PUBLISHED BY FORD MOTOR COMPANY OF CANADA, LIMITED, FORD, ONTARIO, CANADA

JANUARY, 1925

New Design Crankcase Oil Tube

Fig. 42—New

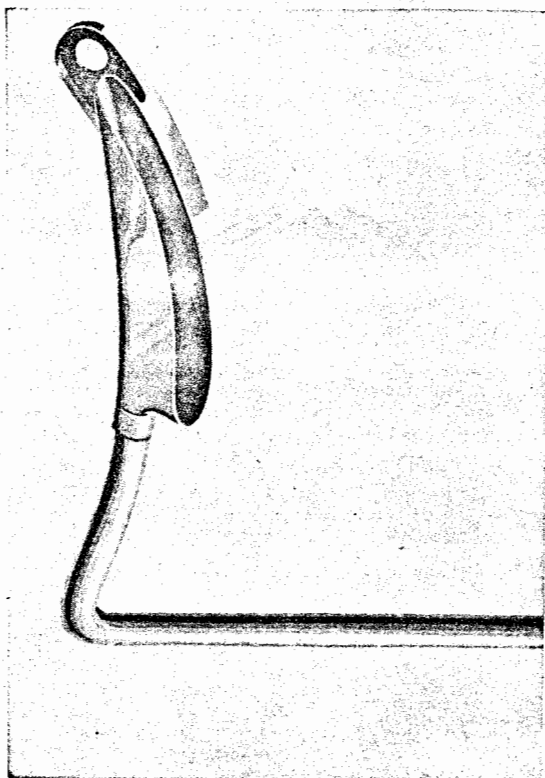
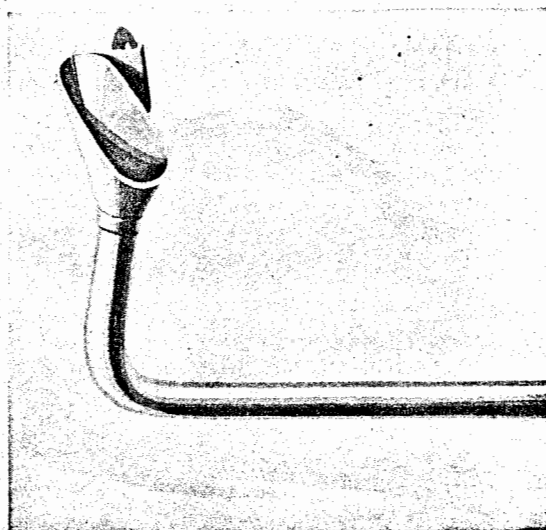
An engineering change was recently made in the crankcase oil tube changing the length of the funnel from $1\frac{1}{2}$ to $3\frac{5}{8}$ ". Figs. 42 and 43 shows the difference in the size of the old and new design oil tubes.

This improvement permits the new design funnel to collect and deliver to the front end of the motor approximately twice as much

oil as was possible with the old style. This is especially advantageous when travelling in mountainous country where steep inclines are frequently encountered. Also, during cold weather when the oil has become congealed and the oil flow is necessarily slow when the engine is started, the larger amount of oil collected by the new type funnel insures the oil reaching the front end of the motor con-

siderably more quickly than would be possible with the old design.

This change also decreases any possibility of clogging of the oil pipe as the additional amount of oil which is collected by the new funnel increases the oil pressure in the pipe sufficiently to carry away any foreign matter that might accumulate.
